PCN Number:	20150831001	PCN Date:	09/02/2015
Title:	New trays for Select Devices		
Customer Contact:	PCN Manager	Dept:	Quality Services
Proposed 1st Ship Date:	12/02/2015		
Change Type:			
<input type="checkbox"/>	Assembly Site	<input type="checkbox"/>	Assembly Process
<input type="checkbox"/>	Design	<input type="checkbox"/>	Electrical Specification
<input type="checkbox"/>	Test Site	<input checked="" type="checkbox"/>	Packing/Shipping/Labeling
<input type="checkbox"/>	Wafer Bump Site	<input type="checkbox"/>	Wafer Bump Material
<input type="checkbox"/>	Wafer Fab Site	<input type="checkbox"/>	Wafer Fab Materials
<input type="checkbox"/>		<input type="checkbox"/>	Part number change
<input type="checkbox"/>		<input type="checkbox"/>	Assembly Materials
<input type="checkbox"/>		<input type="checkbox"/>	Mechanical Specification
<input type="checkbox"/>		<input type="checkbox"/>	Test Process
<input type="checkbox"/>		<input type="checkbox"/>	Wafer Bump Process

27 x 27 Tray Change

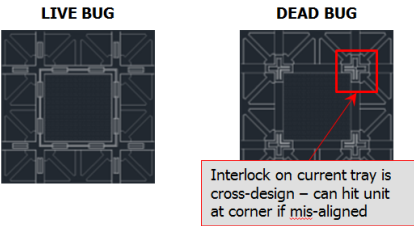
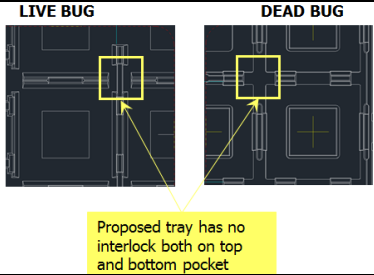
Texas Instruments is pleased to announce the qualification of a new improved tray for the devices listed below. A comparison summary is below:

What	From	To
Stock #/Supplier	420771 & 4072439/Kostat & PEAK	4222142/Daewon
Weight	110 grams	168 grams
Surface Resistivity	10 exp7	10 exp 5
Temperature Rating	150C/180C	150C
Fence	Sharp Edges – Step Up	Circular - Slope
Pocket Design	Pedestal	Slope
Tray Fence	 <p>LIVE BUG</p> <p>DEAD BUG</p> <p>Interlock on current tray is cross-design – can hit unit at corner if mis-aligned</p>	 <p>LIVE BUG</p> <p>DEAD BUG</p> <p>Proposed tray has no interlock both on top and bottom pocket</p>
Tray Pocket	 <p>Simulation shows unit can be caught/stuck on the sharp-edged pedestal causing mis-aligned unit</p>  <p>Unit sits on a sharp-edged pedestal</p>	 <p>No pedestal design on pocket</p>
